TVA-SQN-TS-07-04

**SEQUOYAH NUCLEAR PLANT (SQN) - UNIT 2 - RESPONSE TO REQUEST FOR
ADDITIONAL INFORMATION (RAI) REGARDING LARGE BREAK LOSS-OF-
COOLANT ACCIDENT ANALYSIS METHODS (TAC NO. MD6259)**

TENNESSEE VALLEY AUTHORITY (TVA) SEQUOYAH NUCLEAR PLANT (SQN) UNIT 2

Figure 4-1: Film Boiling Heat Transfer Contribution – Forslund-Rohsenow Limit

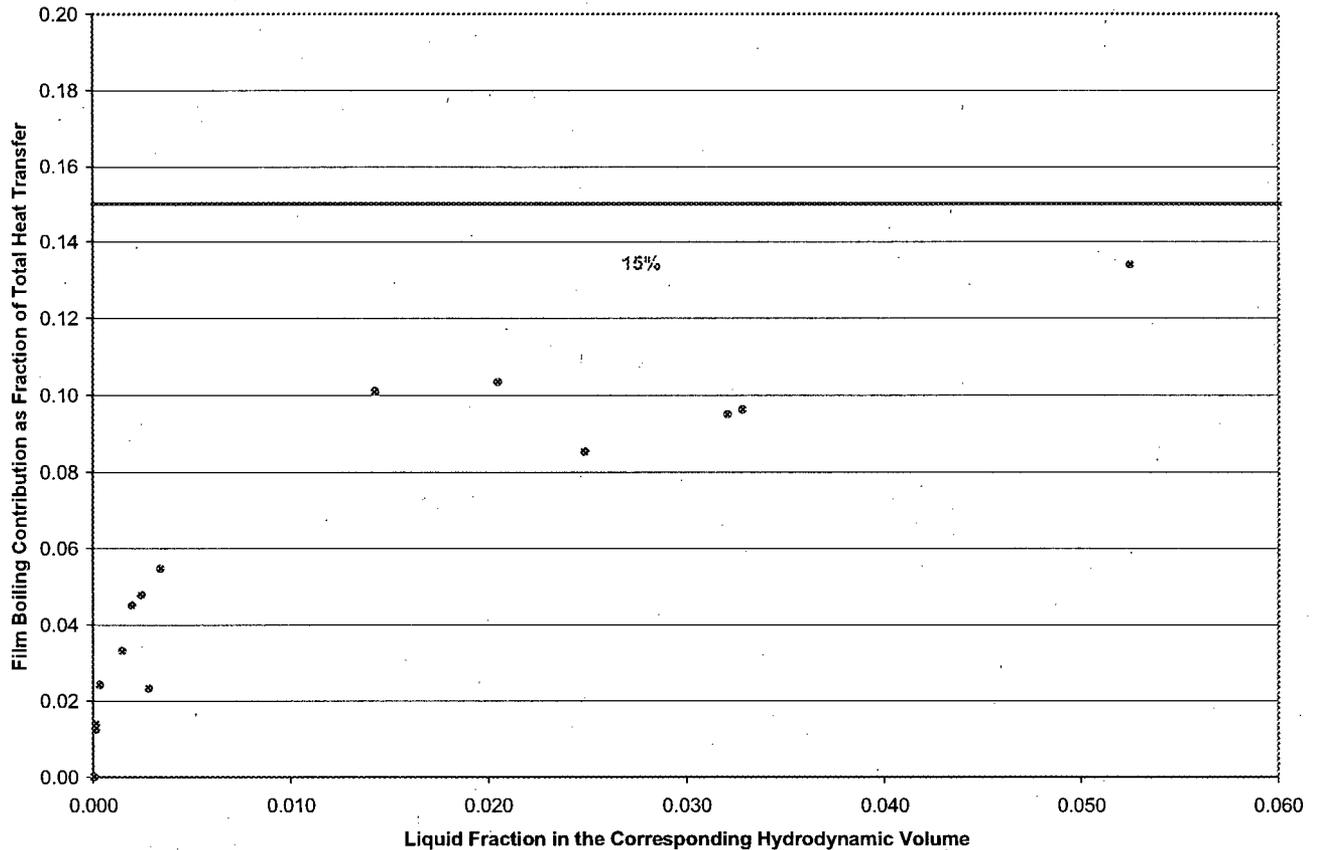
4. In the SQN-2 calculations, is the Forslund-Rohsenow model contribution to the heat transfer coefficient limited to less than or equal to 15 percent when the void fraction is greater than or equal to 0.9?

EMF-2103(P)(A), Revision 0, does not require a limitation on the Forslund-Rohsenow heat transfer correlation. However, as a practical matter, the contribution of Forslund-Rohsenow to the total heat transfer package decreases as the local void fraction increases and is less than 15 percent for void fractions above approximately 97 percent. Figure 4-1 provides a scatter plot, taken from the limiting SQN Unit 2 case, of a sampling of the percentage of the Forslund-Rohsenow contribution to heat transfer as a function of liquid fraction. The sampling includes several points near the time of PCT. As expected, the fluid cooling the hot spot at the time of PCT comprises steam in transition to low liquid fraction. The contribution of Forslund-Rohsenow to the total heat transfer in such a flow is limited, and well below 15 percent. Thus, it can be concluded that there would be no direct influence of a limitation on Forslund-Rohsenow on the resultant limiting PCT for SQN Unit 2.

An indirect effect on PCT may occur because such a limitation may reduce steam generation below the hot spot where the void fraction could reside between 90 percent and 97 percent. Such an impact is expected to be small and does not pose a concern for the conclusions reached by the RLBLOCA evaluation.

In summary, there is no limitation of the contribution of Forslund-Rohsenow to the heat transfer for the SQN Unit 2 RLBLOCA analysis. However, the impact of such a limitation, if it were to be applied, would be minimal and would not lead to an alteration of the conclusions of the analysis that the cladding temperature and local cladding oxidation have been demonstrated to meet the criteria of 10 CFR 50.46 with a high level of probability. For the revised RLBLOCA analysis discussed in the submittal letter, a coding change in S-RELAP5 will be implemented that will not allow the contribution of Forslund-Rohsenow to exceed 15 percent of the total heat transfer.

Figure 9-1: Ice Condenser Sump Configuration

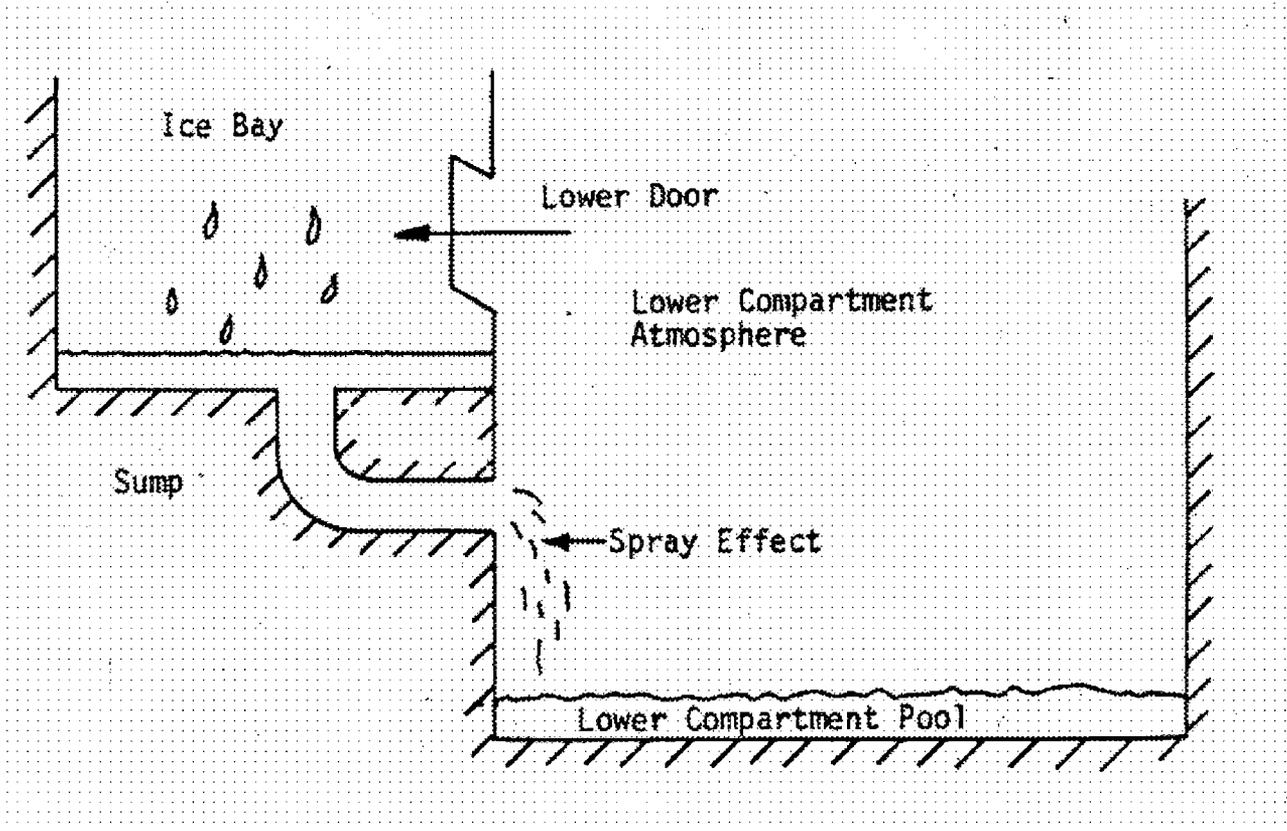
- (a) How is the mixing of containment steam and ice melt modeled so as to minimize the containment pressure?
 - (b) Verify that all containment spray and fan coolers are assumed operating at maximum heat removal capacity.

- (a) In the ice chest, the water formed by melted ice and condensed steam flows to the lower ice chest plenum where it accumulates if the ice bay drains are not large enough to accommodate the rate of water production, Figure 9-1. When the water level in the lower ice chest plenum rises above the bottom of the lower doors, water spillage through the lower doors as well as through the drain ports occurs. The water drainage (spillage plus drainage) from the ice chest falls through the lower compartment vapor. This condenses steam and reduces the containment pressure. The ice chest drainage flow is treated as 100 percent efficient spray during the post-blowdown period of the transient.
